TECHNICAL SERVICE BULLETIN

Squeak Or Rattle Noise From The Center Display Screen

23-2395

Lincoln 2023 Corsair

Figure 1

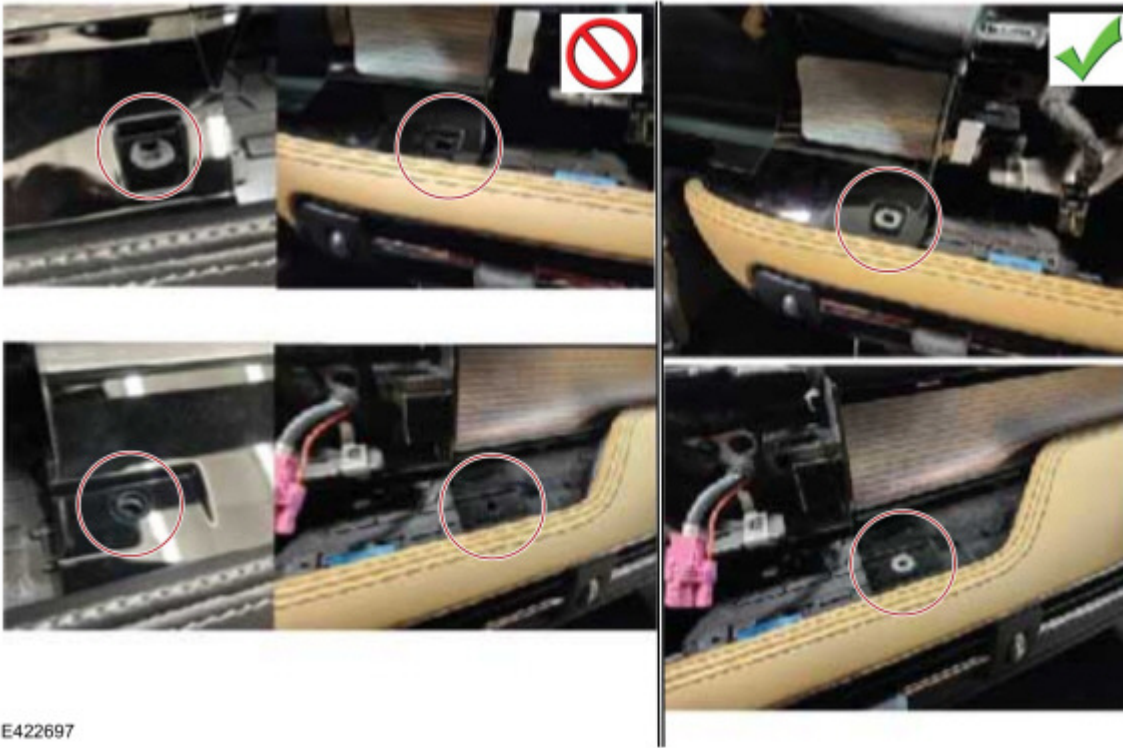
2. Inspect the grommets in the instrument panel that the center display screen dowels insert into. Are one or both of the grommets in the instrument panel damaged or missing? (Figure 1).

- (1). Yes - if one grommet is damaged or missing, remove both or the remaining grommet. Proceed to Step 3.
- (2). No - proceed to Step 4.

Figure 2

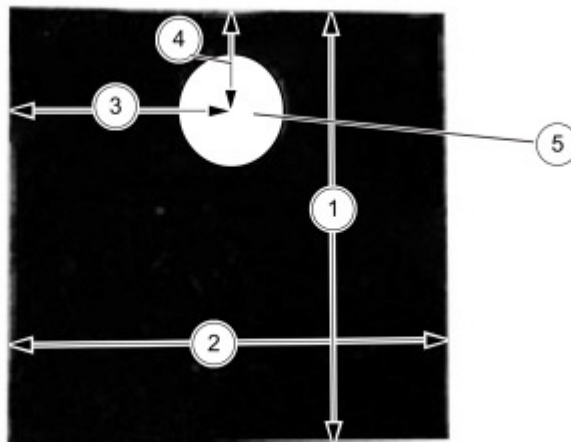
3. Cut 2 pieces of flock tape to the following dimensions: 30mm long x 30mm wide and create 7mm diameter hole as indicated in Figure 2.

Figure 3

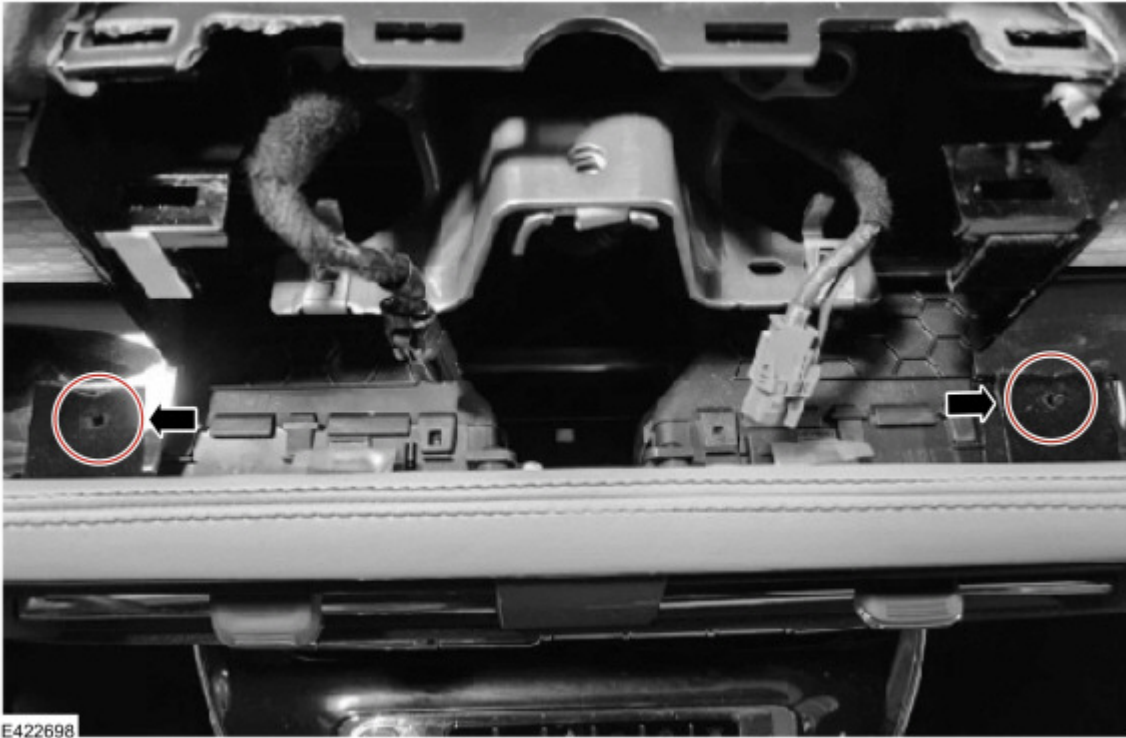
- (1). Position the 2 pieces of flock tape in the grommet locations. (Figure 3)

Figure 5

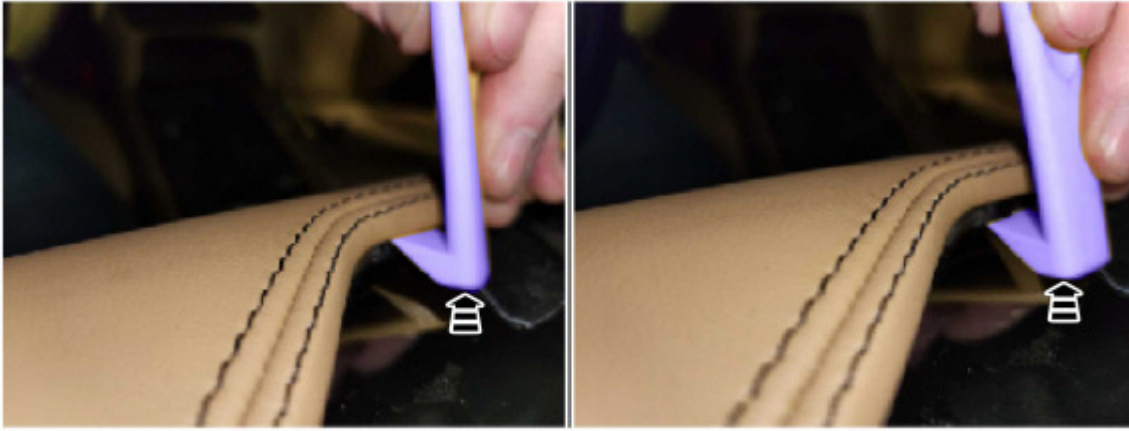
NOTE: A plastic trim tool can be used to fit the tape and carefully tuck it underneath the leather trim panel. (Figure 5)
